UNITED STATES PATENT AND TRADEMARK OFFICE

APPLICATION NO.	FILING DATE	FIRST NAMED INVENTOR	ATTORNEY DOCKET NO.	CONFIRMATION NO.
10/628,500	07/28/2003	Makoto Miyazawa	NEKU 20.544	5066
26304	7590	06/28/2005	EXAMINER	
KATTEN MUCHIN ROSENMAN LLP			NGUYEN, KHIEM D	
575 MADISON AVENUE			ART UNIT	
NEW YORK, NY 10022-2585			PAPER NUMBER	
			2823

Office Action Summary

DETAILED ACTION

FIG. 3

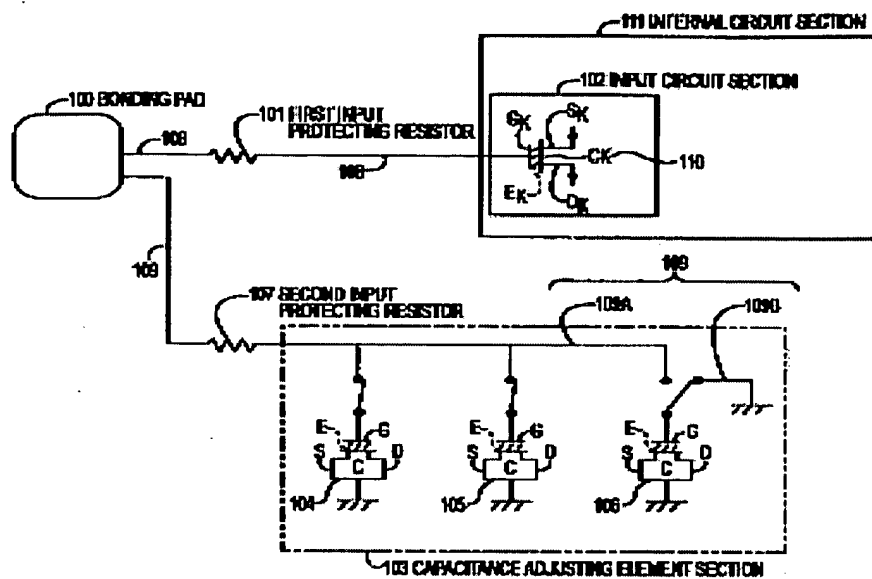
In re claim 1, **Matsui** discloses a semiconductor integrated circuit device comprising: a terminal **100**; and a first capacitance adjusting section **103** which is connected to a wiring between the terminal and a protection resistor **101** in front stage of an internal circuit **111** (col. 7, line 39 to col. 8, line 65 and FIG. 3),

wherein the first capacitance adjusting section adjusts terminal capacitance of the terminal, based on capacitance of the first capacitance adjusting section (col. 7, line 39 to col. 8, line 65).

In re claim 3, Matsui discloses that the first capacitance adjusting section comprises a first adjusting capacitor which adjusts the terminal capacitance (col. 7, line 39 to col. 8, line 65 and FIG. 3),

In re claim 9, Matsui discloses that the semiconductor integrated circuit device according to Claim 8, wherein the well potential control section comprises: a plurality of resistors **101, 107** which are connected in series to each other between two potential electrodes; and a plurality of switches **104, 105, 106** each of which is connected in parallel to each of the plurality of resistors (FIG. 3),

In re claim 10, **Matsui** discloses that the semiconductor integrated circuit device according to Claim 9, further comprising: a plurality of the terminals **100**; and a plurality of the first capacitance adjusting sections **103** each of which is connected to each of a plurality of the wirings **108, 109** between each of the plurality of terminals **100** and each of a plurality of the protection resistors **101, 107**, wherein the well potential control section controls each of a plurality of said well region potentials (col. 7, line 39 to col. 8, line 65 and FIG. 3).

Fig. 4

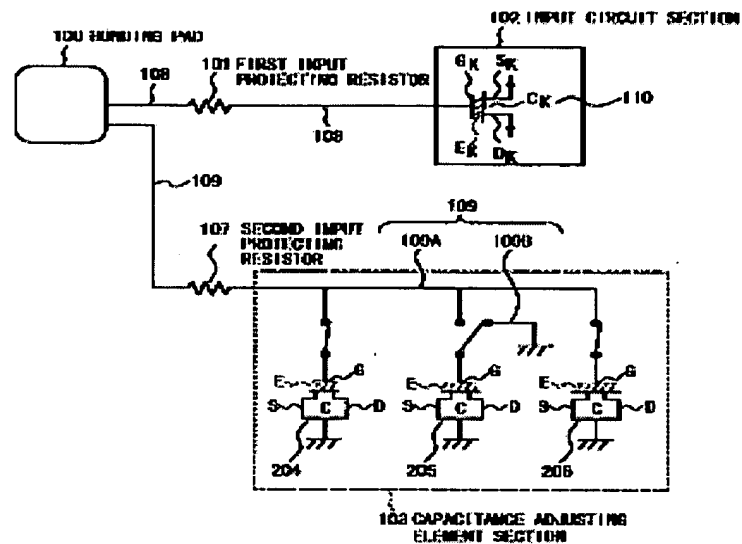
In re claim 2, Matsui discloses that the semiconductor integrated circuit device according to Claim 1, further comprising: a protection circuit which is connected to the wiring between the adjusting terminal and the first capacitance section and protects the internal circuit (FIG. 4).

the first adjusting capacitor comprises: a first semiconductive portion which is composed of a first well region formed in a substrate with the internal circuit and having a conductive type opposite to that of the substrate, and a second semiconductive portion which is opposite to the first semiconductive portion and is composed of a first diffusion layer region formed in the first well region and having the same conductive type as that of the substrate (col. 7, line 62 to col. 8, line 39 and FIG. 4).

opposite to that of the substrate, and a second semiconductive portion which is opposite to the first semiconductive portion and is composed of a first diffusion layer region formed in the first well region and having the same conductive type as that of the substrate (col. 7, line 62 to col. 8, line 39 and FIG. 4).

In re claim 8, Matsui discloses that the semiconductor integrated circuit device according to Claim 7, further comprising: a well potential control section wherein the first capacitance adjusting section further comprises a second adjusting capacitor which adjusts the terminal capacitance based on controlling a well region potential by the well potential control section, the second adjusting capacitor comprises: a third semiconductive portion which is composed of a second well region formed in the substrate and having a conductive type opposite to that of the substrate, a fourth semiconductive portion which is opposite to the third semiconductive portion and is composed of a second diffusion layer region formed in the second well region and having the same conductive type as that of the substrate, and the well potential control section controls the well region potential of the second well region (col. 7, line 62 to col. 8, line 39 and FIG. 4).

In re claim 12, Matsui discloses that the semiconductor integrated circuit device according to Claim 11, wherein the switching control section comprises: a plurality of switches **104**, **105**, **106** each of which outputs signal potentials corresponding to turn on and off of the each of plurality of switches, and a plurality of signal holding sections each of which holds corresponding each of a plurality of the signal potentials wherein the switching control section controls the capacitance of the second capacitance adjusting section based on the plurality of signal potentials (FIG. 4).

adjusting section adjusts the plurality of third adjusting capacitors based on the plurality of signal potentials (FIG. 4).

Fig. 5

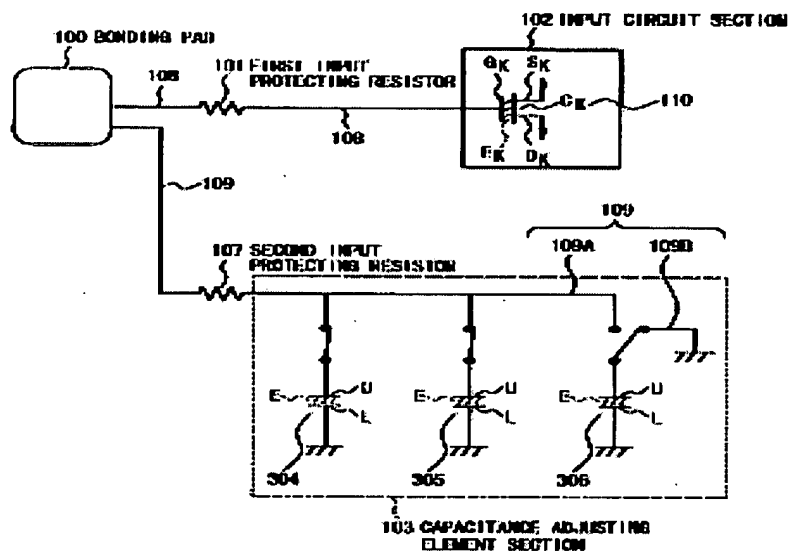
In re claim 11, **Matsui** discloses that the semiconductor integrated circuit device according to Claim 1, further comprising: a second capacitance adjusting section which is connected to a wiring between the first capacitance adjusting section and the internal circuit, wherein the second capacitance, adjusting section adjusts the terminal capacitance based on capacitance of the second capacitance adjusting section; and a switching control section which controls the capacitance of the second capacitance adjusting section (FIG. 5).

Fig. 6

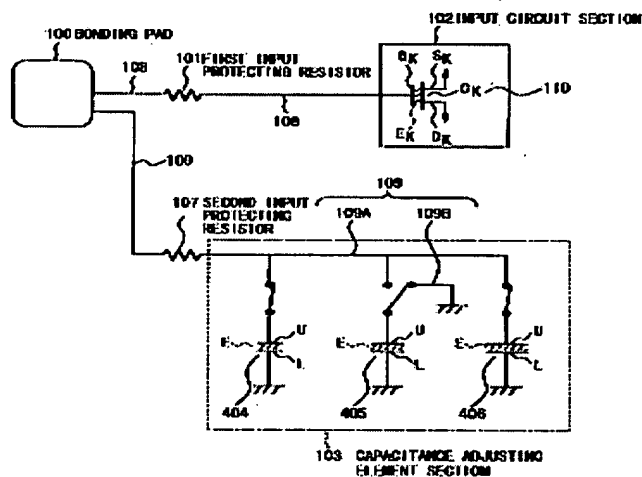
In re claim 14, Matsui discloses that the semiconductor integrated circuit device according to Claim 13, further comprising: a plurality of said terminals; and a plurality of the second capacitance adjusting sections each of which is connected to each of a plurality of the wirings between each of the plurality of the first capacitance adjusting sections and each of a plurality of the internal circuits, wherein the switching control section controls each of a plurality of said capacitances of the plurality of second capacitance adjusting sections (col. 4, line 54 to col. 11, line 10 and FIG. 6).

section which controls said capacitance of said second capacitance adjusting section (col. 10, line 54 to col. 11, line 10 and FIG. 6).

In re claim 16, **Matsui** discloses that the semiconductor integrated circuit device according to Claim 15, wherein the switching control section comprises: a plurality of switches each of which outputs signal potentials corresponding to turn on and off of each of plurality of switches, and a plurality of signal holding sections each of which holds corresponding each of a plurality of said signal potentials, wherein the switching control section controls the capacitance of the second capacitance adjusting section based on the plurality of signal potentials (FIG. 6).

In re claim 17, **Matsui** discloses that the semiconductor integrated circuit device according to Claim 16, wherein the second capacitance adjusting section comprises: a plurality of third adjusting capacitors each of which capacitance is variable based on corresponding the each of the plurality of signal potentials, wherein the second capacitance adjusting section adjusts the plurality of third adjusting capacitors based on the signal potential (col. 10, line 54 to col. 11, line 10 and FIG. 6).

In re claim 18, **Matsui** discloses that the semiconductor integrated circuit device according to Claim 17, further comprising: a plurality of said terminals; and a plurality of the second capacitance adjusting sections each of which is connected to each of a plurality of the wirings between each of the plurality of the first capacitance adjusting sections and each of a plurality of the internal circuits, wherein the switching control section controls each of a plurality of the capacitances of the plurality of second capacitance adjusting sections (col. 10, line 54 to col. 11, line 10 and FIG. 6).
